Docket Number:	85-AFC-03C
Project Title:	Compliance - Application for Certification for Midway-Sunset Cogeneration Project
TN #:	201327
Document Title:	Midway Sunset Cogeneration Divestiture of a Portion of Its Main Steam Line
Description:	Midway Sunset Cogeneration Divestiture of a Portion of Its Main Steam Line
Filer:	Mary Dyas
Organization:	Midway Sunset Cogeneration Company
Submitter Role:	Applicant
Submission Date:	11/25/2013 1:58:44 PM
Docketed Date:	11/25/2013

Subject: Midway Sunset Cogeneration Company (MSCC) Divestiture of a Portion of Its Main Steam Line.

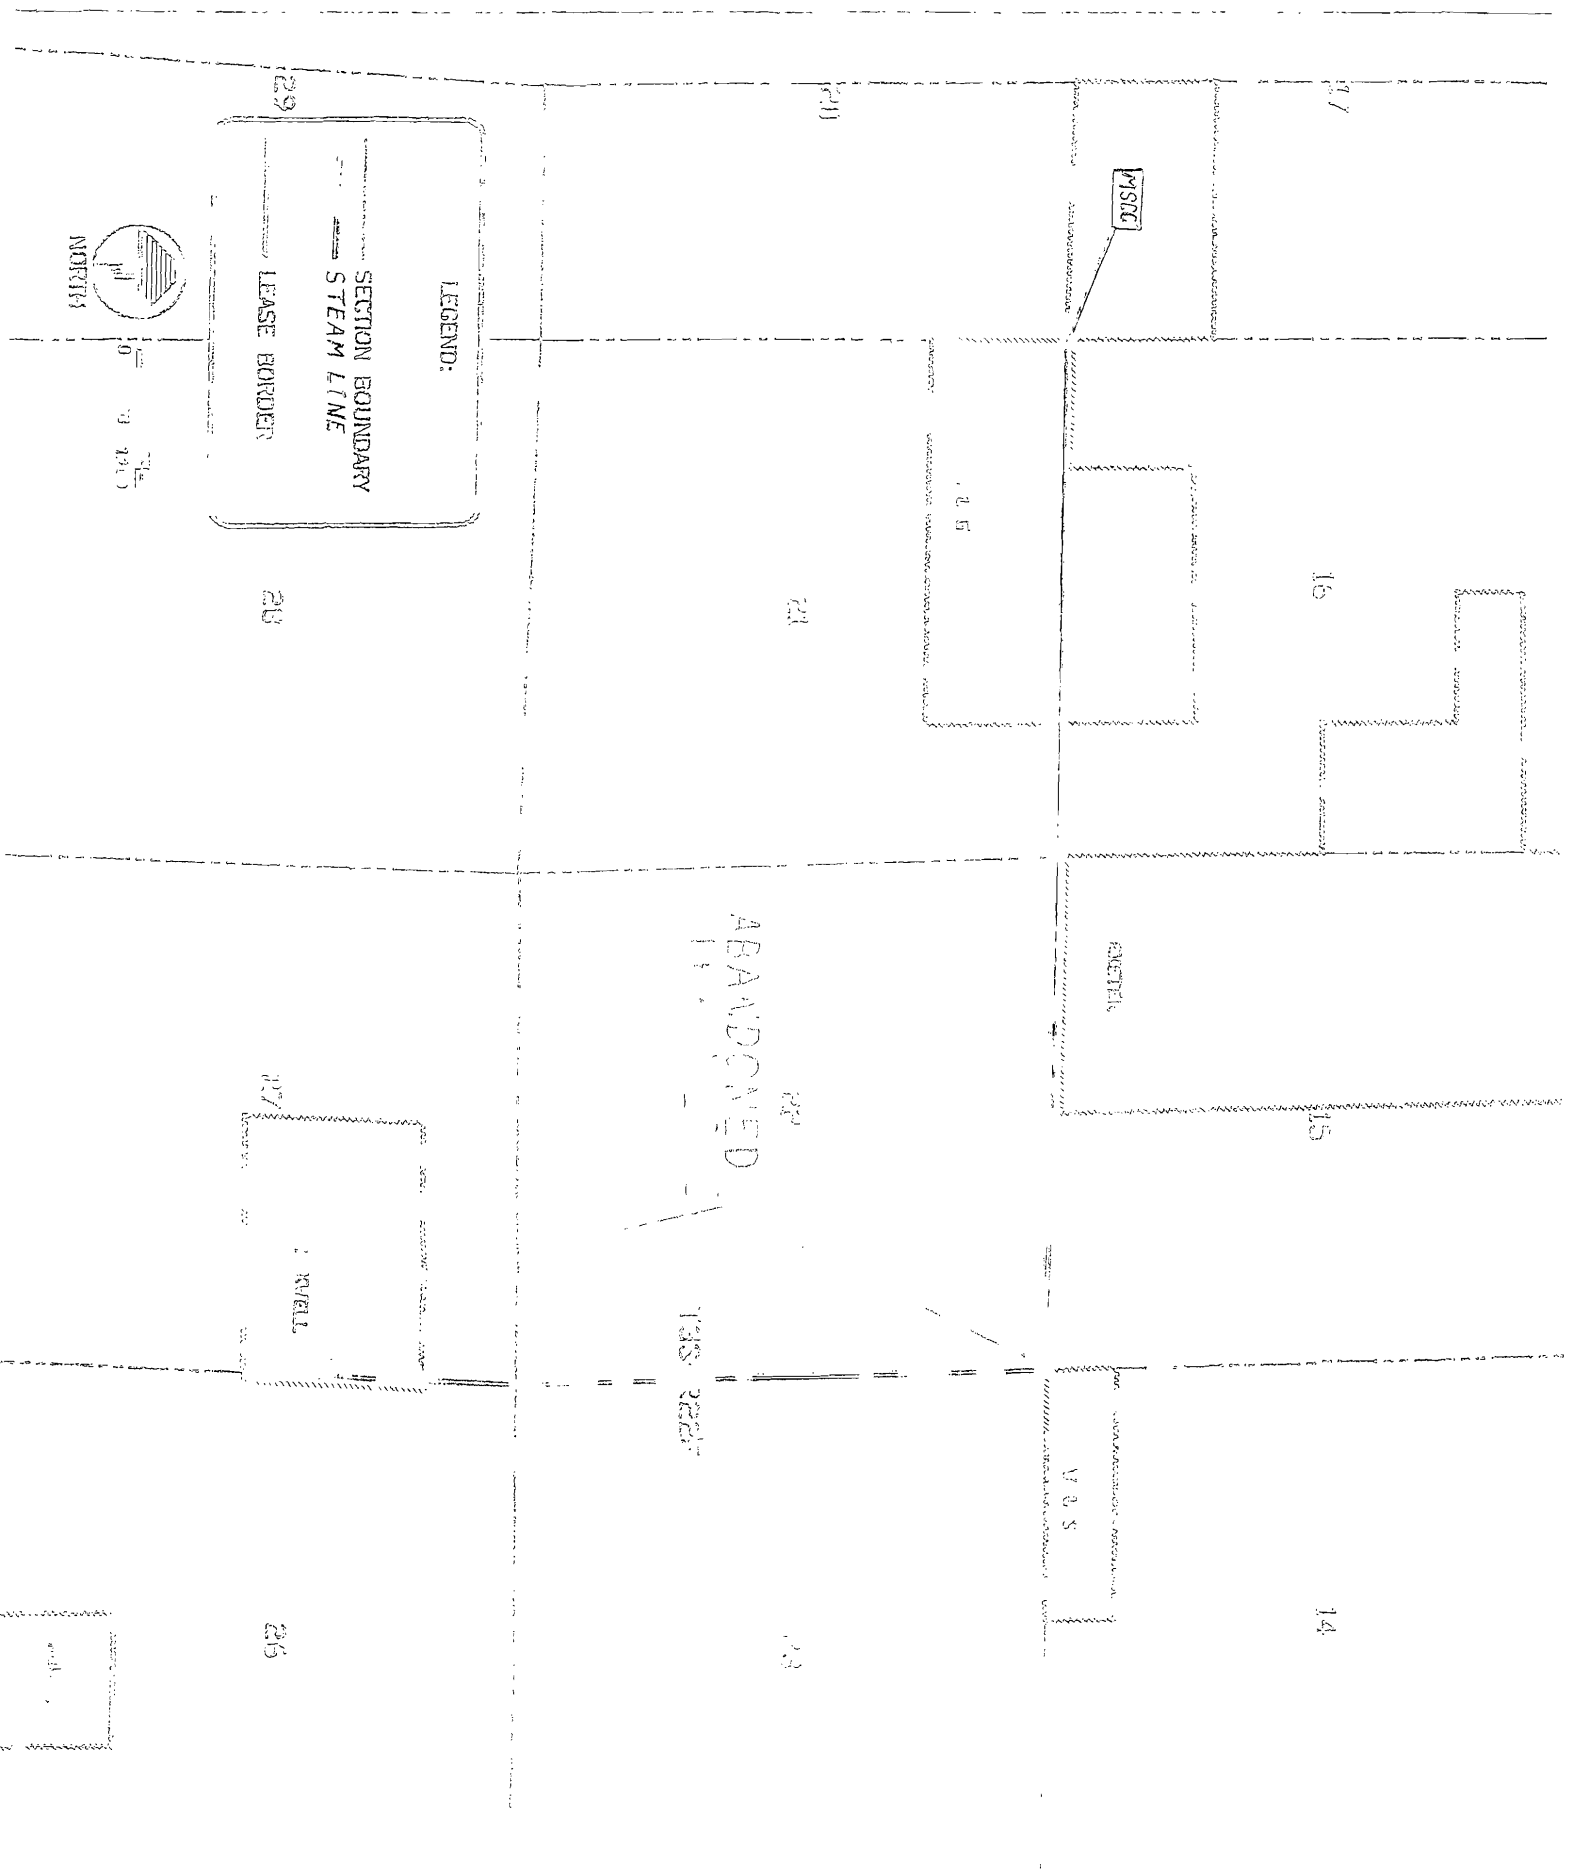
Please accept this as a letter of notification of MSCC's divestiture of approximately 9000 feet of the originally designed steam distribution system. If it is determined that a Post Certification Amendment is required, please find attached a draft copy. If needed, the draft copy can be signed by MSCC's Executive Director and formally submitted.
